# Public Notice of Request for Permit Modification

<b>PUBLIC NOTICE DATE:</b>	<b>February 4, 2022</b>
<b>EXPIRATION DATE:</b>	<b>March 7, 2022</b>
<b>REFERENCE NUMBER:</b>	<b>POA-1994-01014</b>
<b>WATERWAY:</b>	<b>Orca Inlet</b>

**SHEPARD POINT OIL SPILL  
RESPONSE FACILITY PROJECT**  
 APPLICANT: NATIVE VILLAGE OF EYAK  
 FILE NO.: POA-1994-1014, ORCA INLET  
 PROPOSED ACTIVITY:  
**LINEAR TRANSPORTATION PROJECT**  
**ORCA INLET**  
**PRINCE WILLIAM SOUND**  
 NAD 1983 StatePlane Alaska FIPS 5003 US Feet

NEW SMALL BOAT RAMP STRUCTURE  
PLAN & SECTION

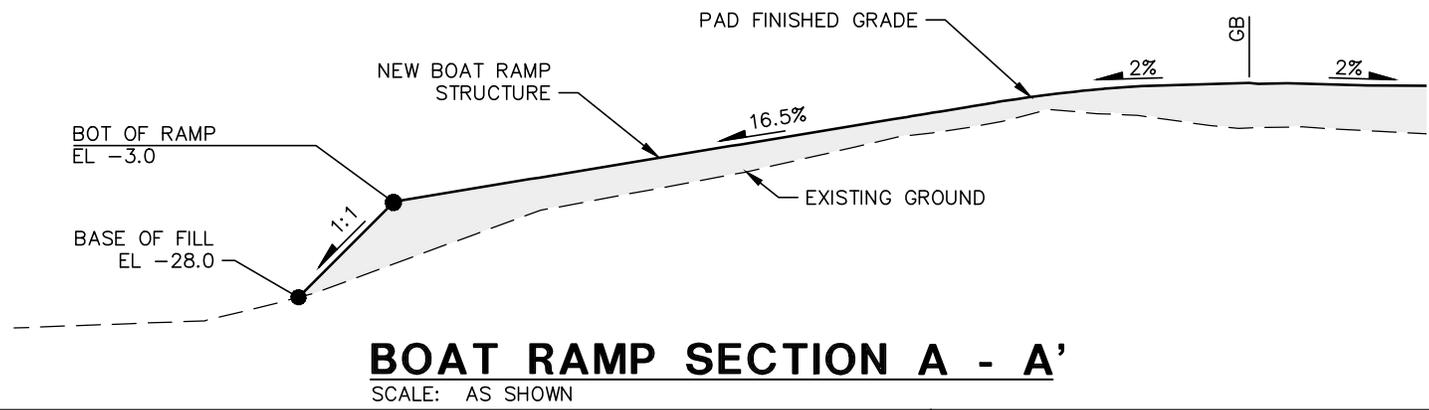
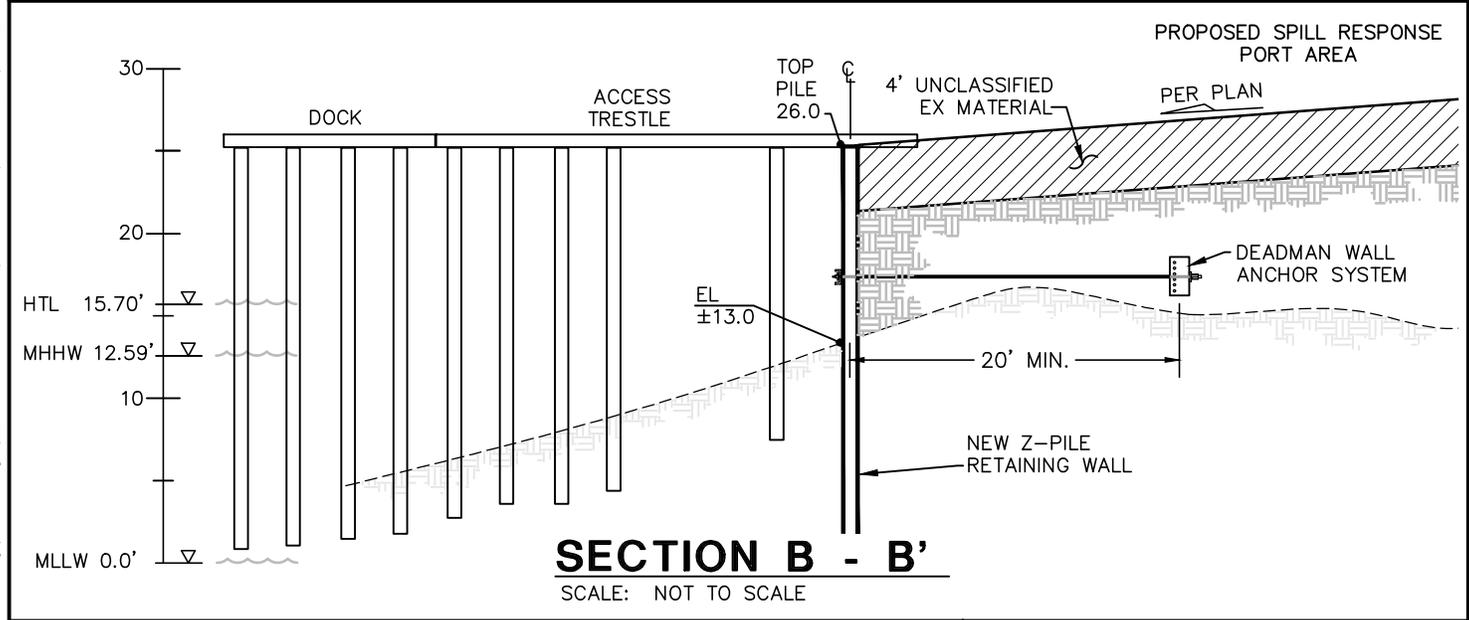
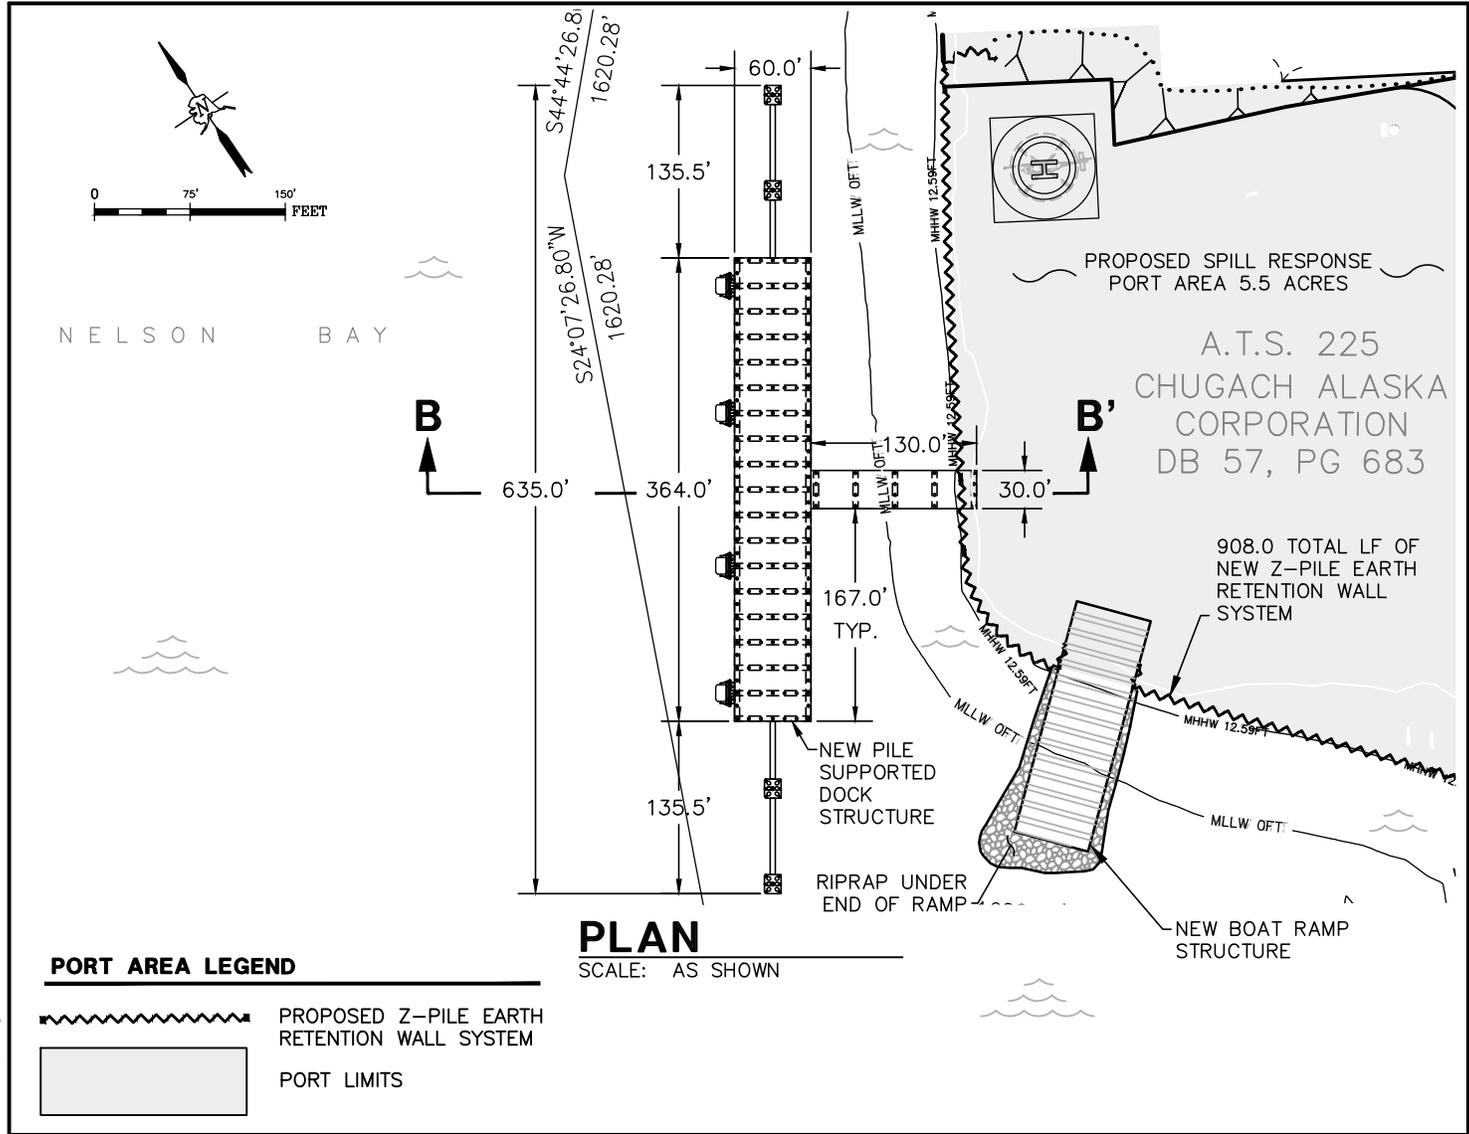
6) Boat ramp configuration change: The proposed modification includes 187.5-foot by 60-foot boat ramp at the Shepard Point pad and staging area. The 2017, DA permit authorizes a 200-foot by 35-foot boat ramp at this location.
